PRAIRIE ISLAND NUCLEAR GENERATING PLANT

**Additional Information on Proposed Revision to Main
Steam Line Break Methodology Dated June 26, 1997**

Outline for Discussion with NRC on MSLB Submittal, 4/16/99

**Responses to the questions asked during the MSLB NRC conference
call on April 16th 1999**

Figure 1
WCAP-8822, Fig. 2.4-2 & Fig. 2.4-5
Model D Steam Generator

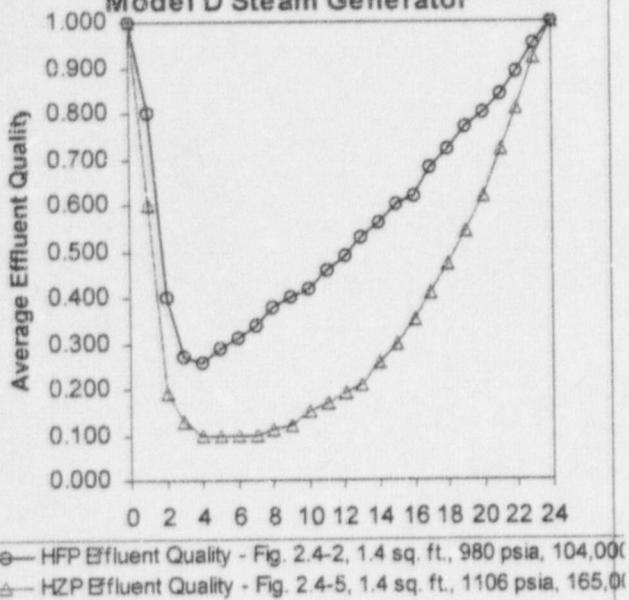
1. In WCAP-8822, Figures 2.4-2 & 2.4-5, represent the average effluent quality response for a 1.4 ft² DER at 102% power and Hot Standby, respectively (see attached figure 1).

Figure 2
WCAP-8822, Fig. 2.4-2 & Fig. 2.4-5
Adjusted to account for SG Mass
Diff.

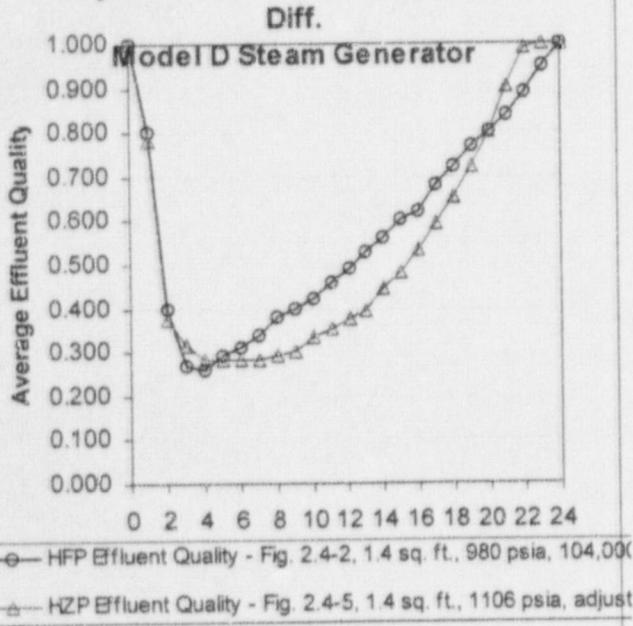
3. The incremental change in average effluent quality due to changes in initial SG water mass was then applied to the data in Figure 2.4-5.
4. By accounting for a reduction in the initial SG water mass for the Hot Standby case, the average effluent quality was increased by approximately 0.18.

5. Once the initial SG water mass is equivalent between the Full power case and the Hot Standby case, the average effluent quality response is quite similar. Hence, using sensitivities performed by Westinghouse in WCAP-8822, Table 2.2.1-1 demonstrate that the secondary effects of the RCS temperature profile do not contribute significantly to the average effluent quality for a 1.4 ft² break.

Figure 3
WCAP-8822, Fig. 2.4-5 & Fig. 2.2.1-2

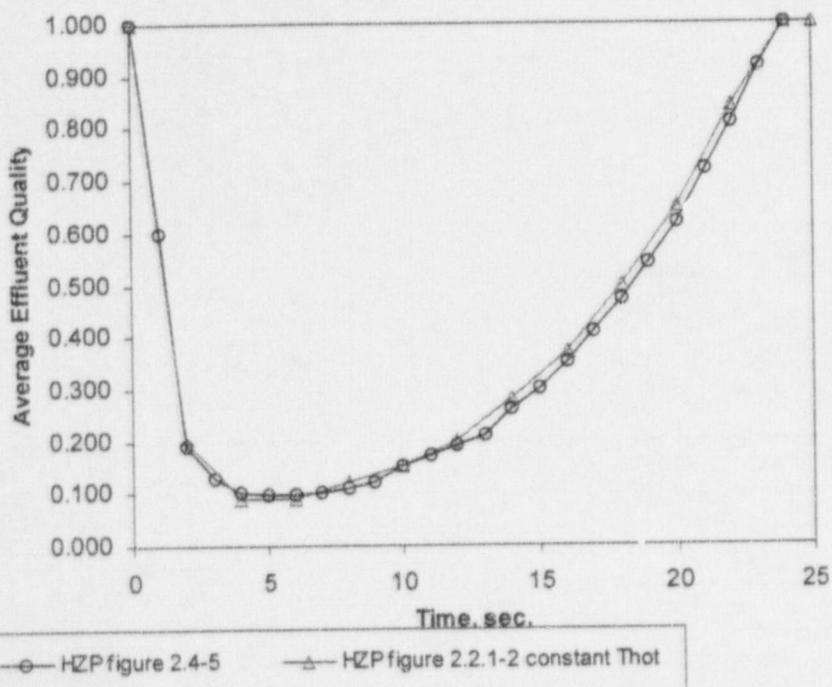
WCAP 8822 talks about iterations between TRANSFLO and MARVEL while generating the entrainment curves. Thus, it is reasonable to conclude that, for figure 2.4-5, the primary system temperature was decreasing. In the generation of Figure 2.2.1-2 the primary system temperature, T_{hot} , was held constant.

Thus, comparing figure 2.2.1-2 to 2.4-5 may be as an indicator of how sensitive entrainment is to the primary side parameters. The quality vs. time data in these two figures is essentially identical, see attached figure 3, suggesting that entrainment is not sensitive to differences in the primary side parameters. This supports the use of entrainment curves generated based on a 3-4 loop for application to a 2-loop design.

Core Response With & Without Decay Heat

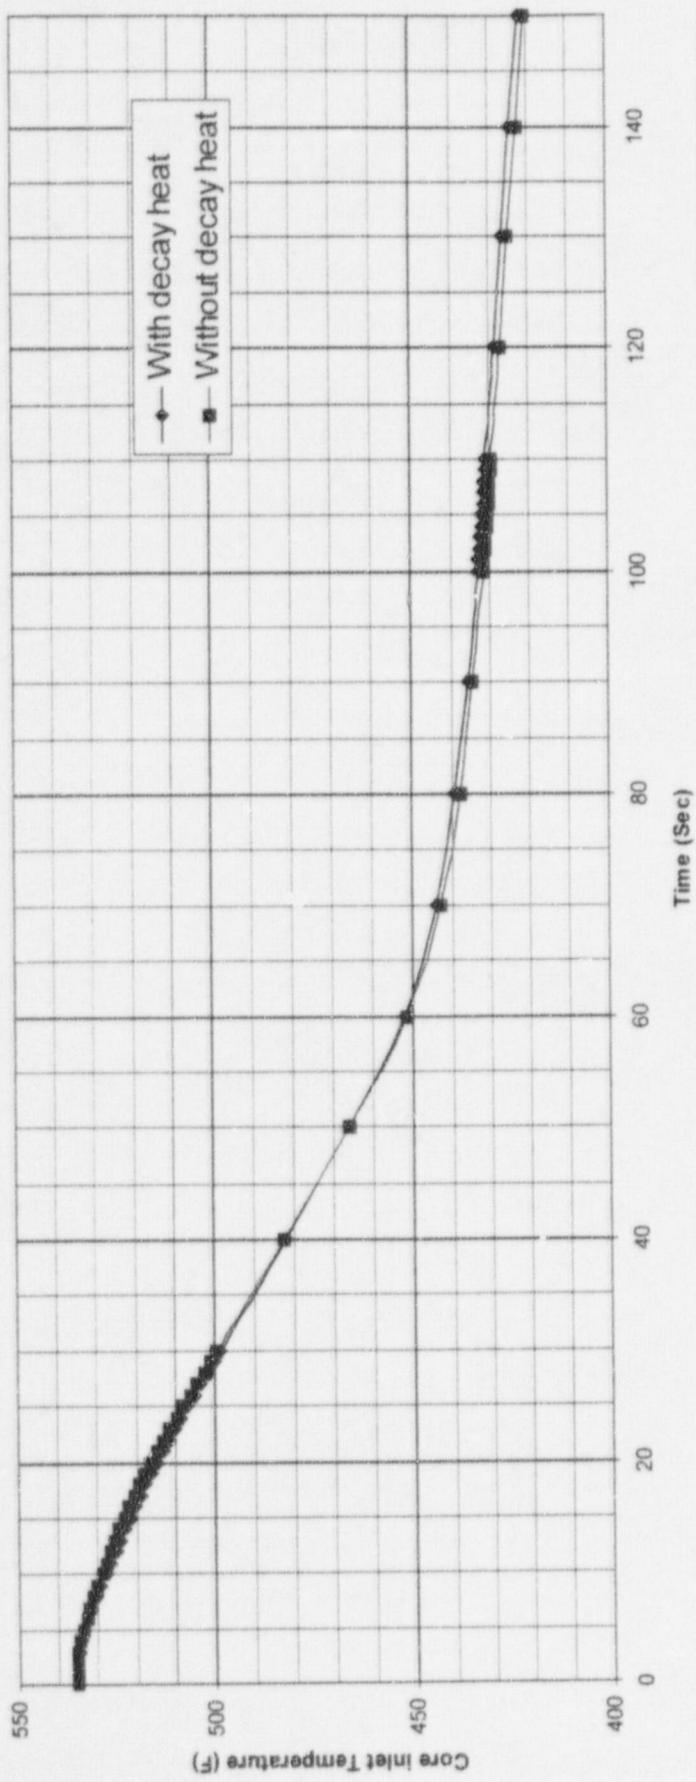
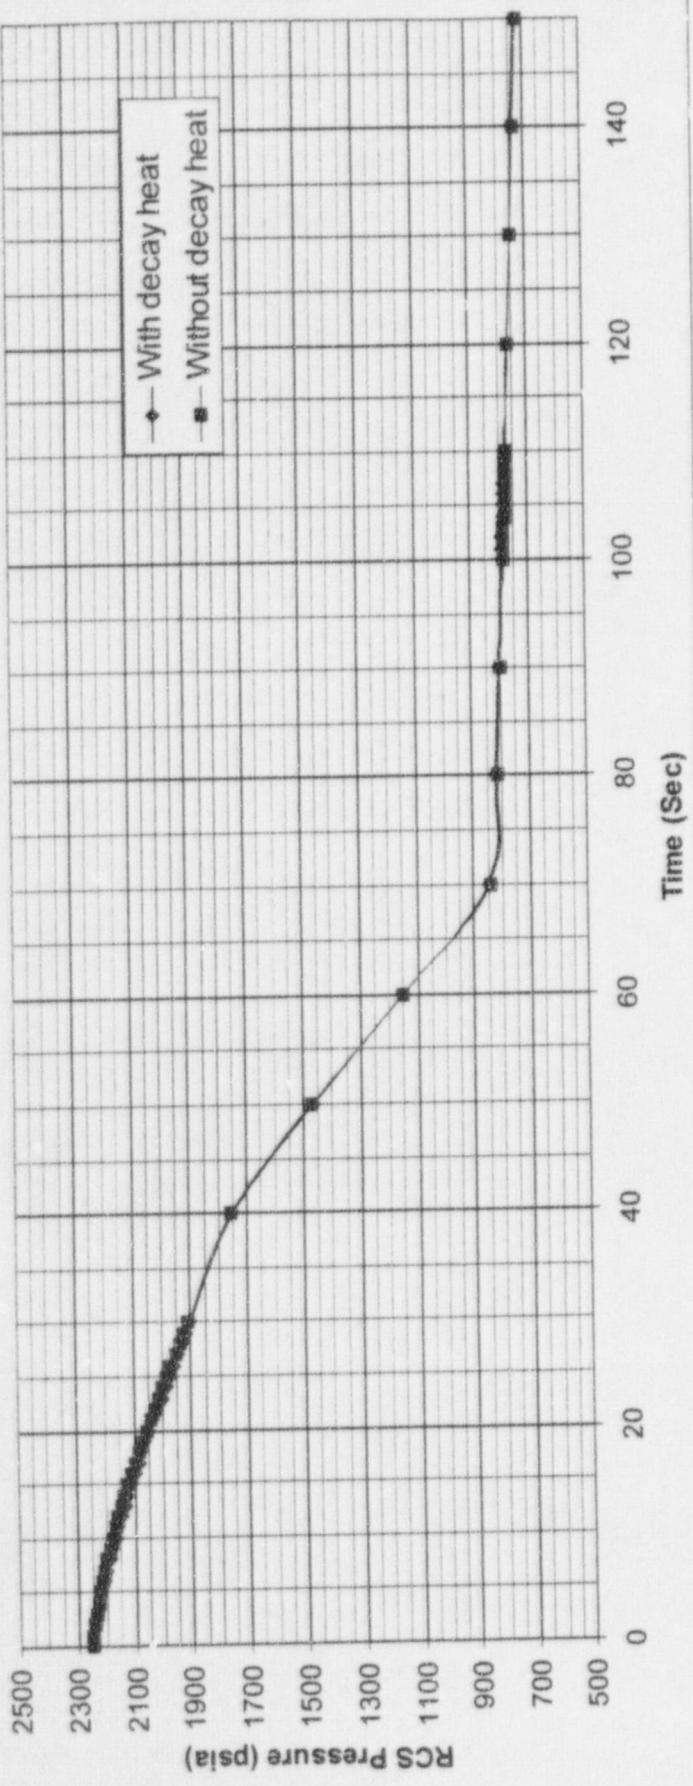
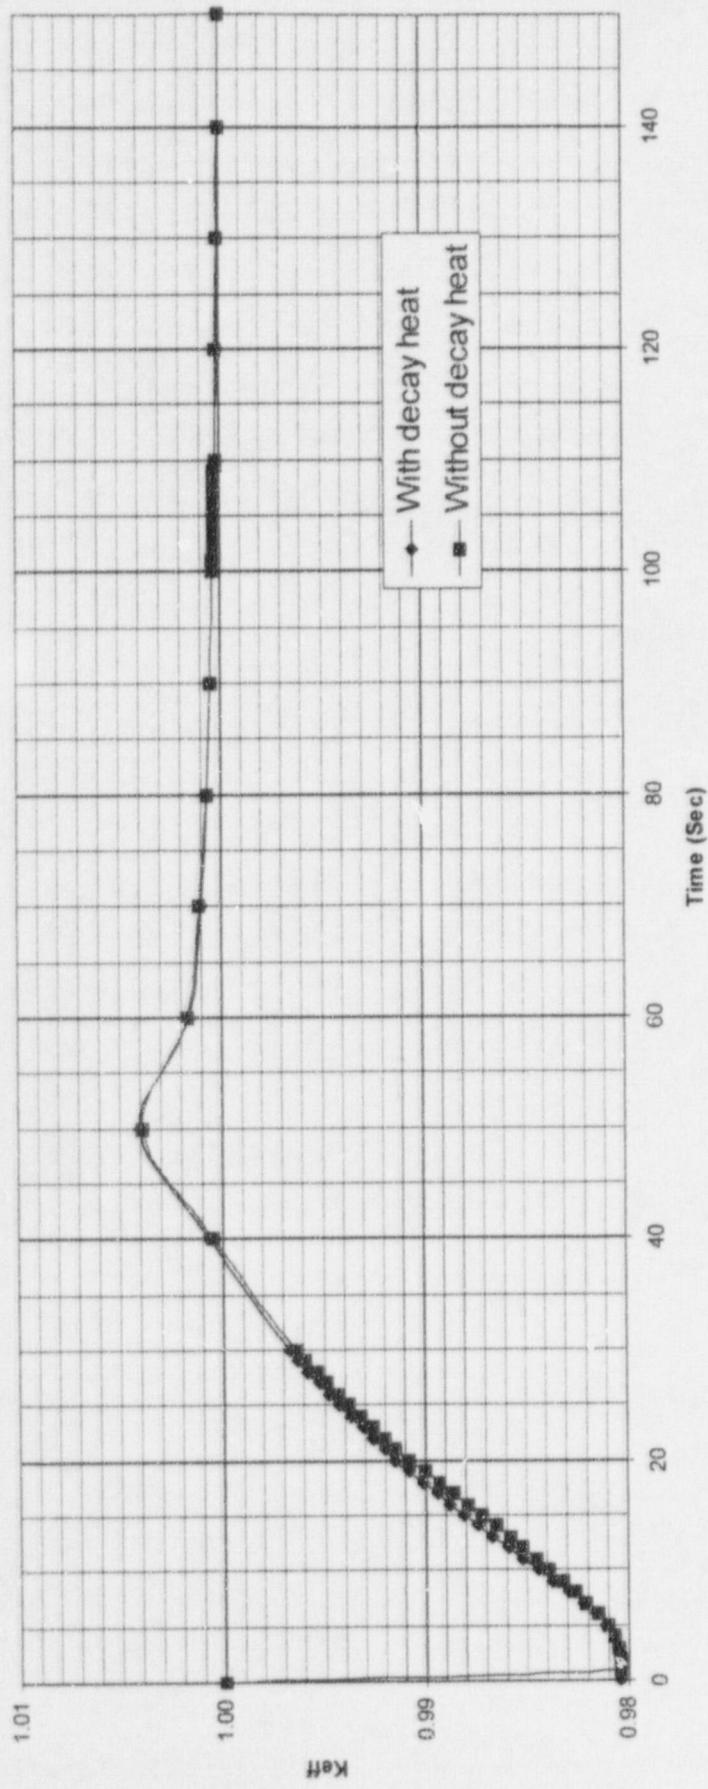
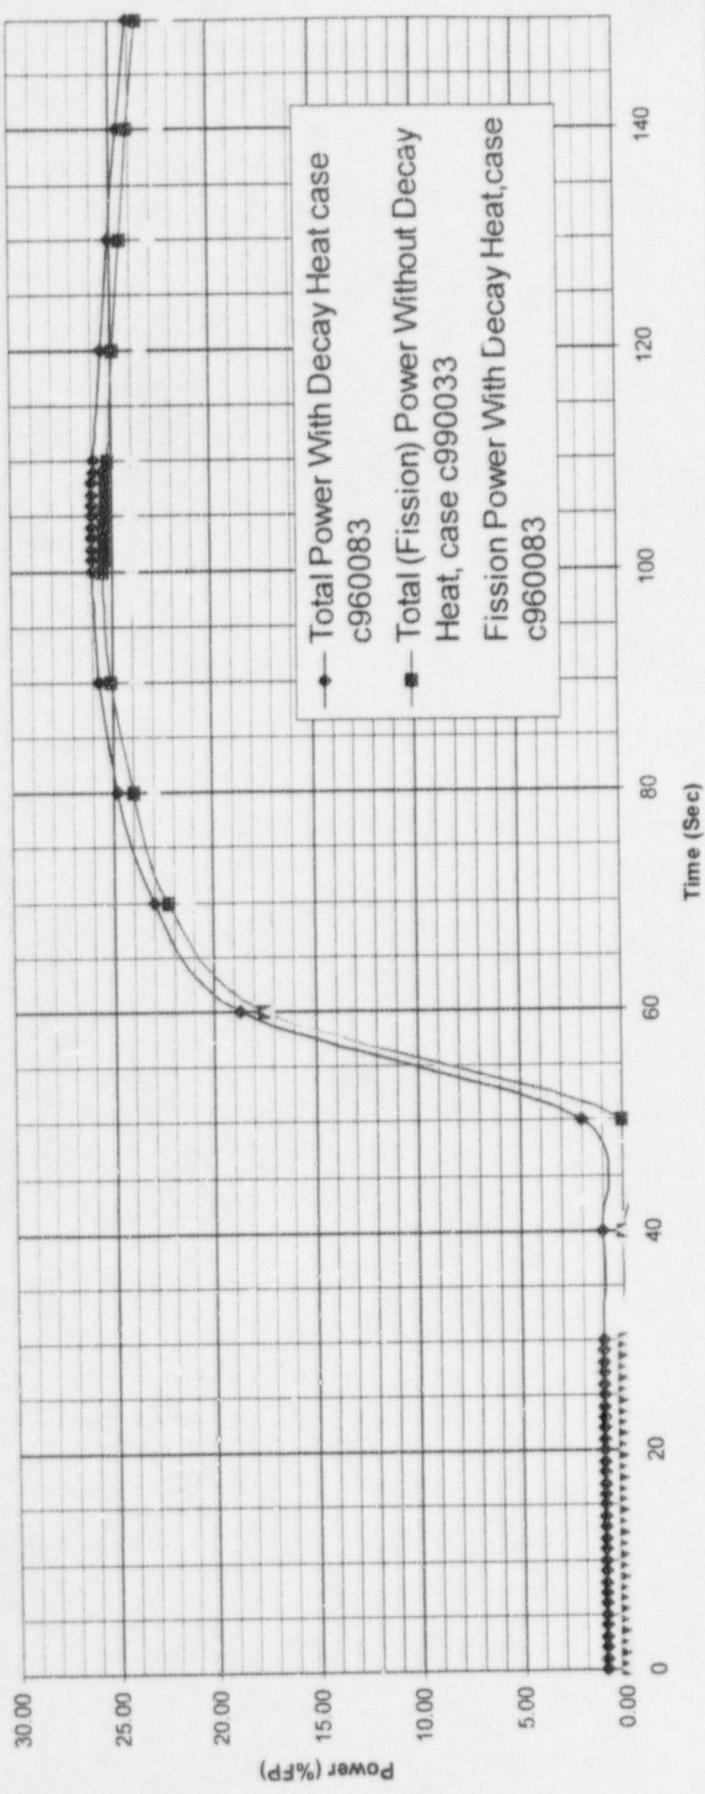
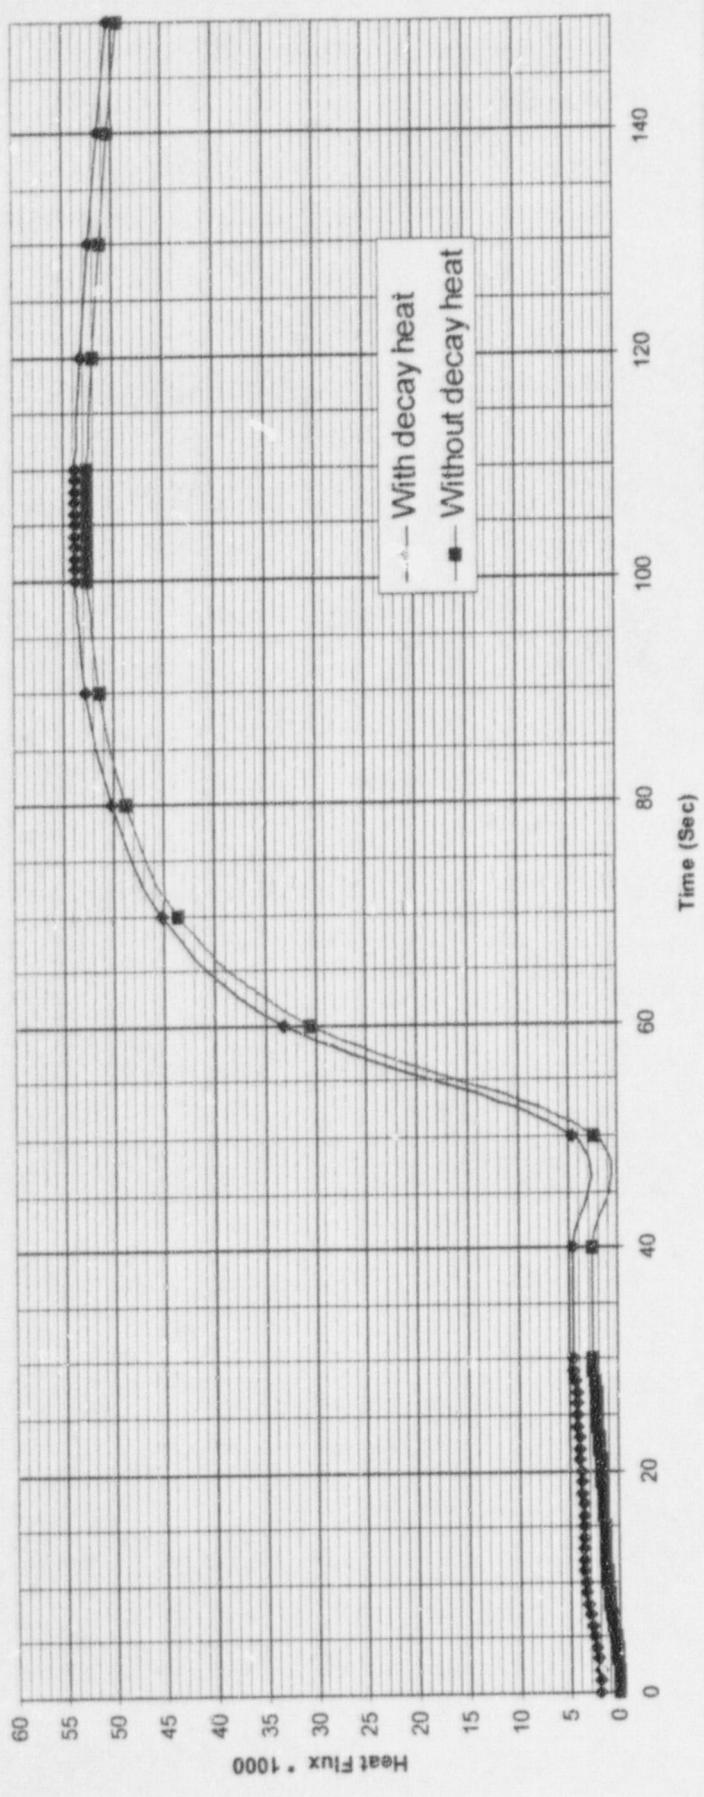
1) Question relating to Modeling decay heat in core response cases.

Re-ran the limiting core response case in NSPNAD-97002 turning off decay heat. This resulted in an increase in the MDNBR of 0.096. Generated comparison plots of following parameters versus time:

Core inlet temperature (without decay heat, cools down faster)
 K_{eff} (both peak at 1.004)
RCS pressure (negligible change)
Power due to just fission, modeling decay heat (max 24% FP)
Power due to Fission and decay heat (i.e. Total) (max 26% FP)
Power due to fission without modeling decay heat (max 25.5% FP)
Heat Flux (53,000 btu/hr-ft² without DH vs. 54,000 btu/hr-ft² with DH)

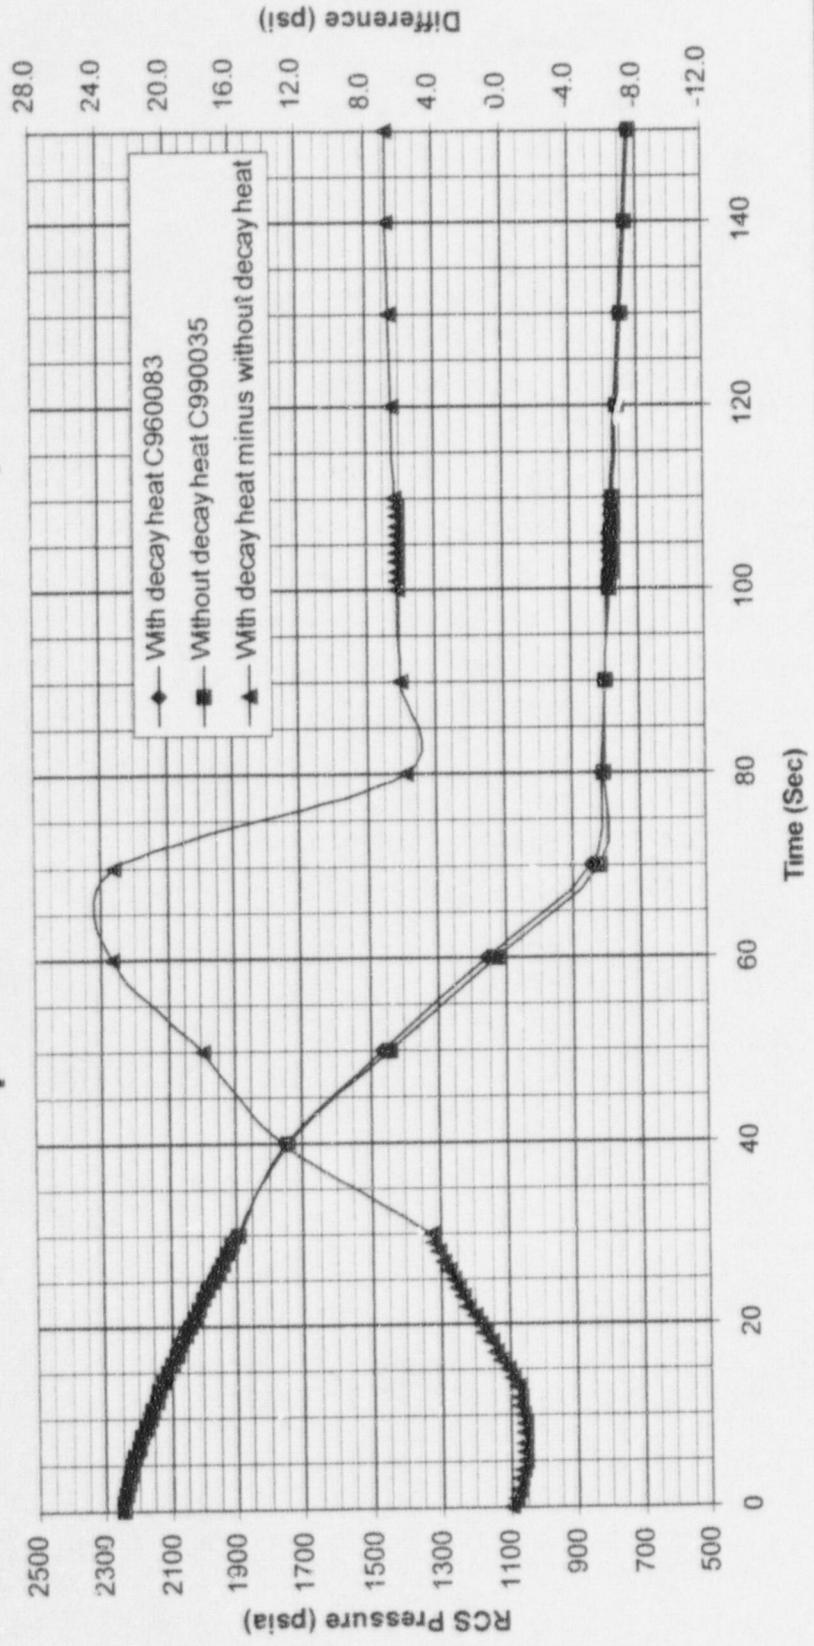
What is the area of the steam pipes and the unisolated portion of the steam pipe?

The inside diameter of Prairie Island's Steam Pipes is 27.951 inches.

The unisolated portion of the steam pipe is 556 cubic feet. The steam in this portion of the pipe is accounted for by increasing the volume of the steam generator by 556 cubic feet. Thus, contents of the unisolated portion are allowed to blow down to containment.
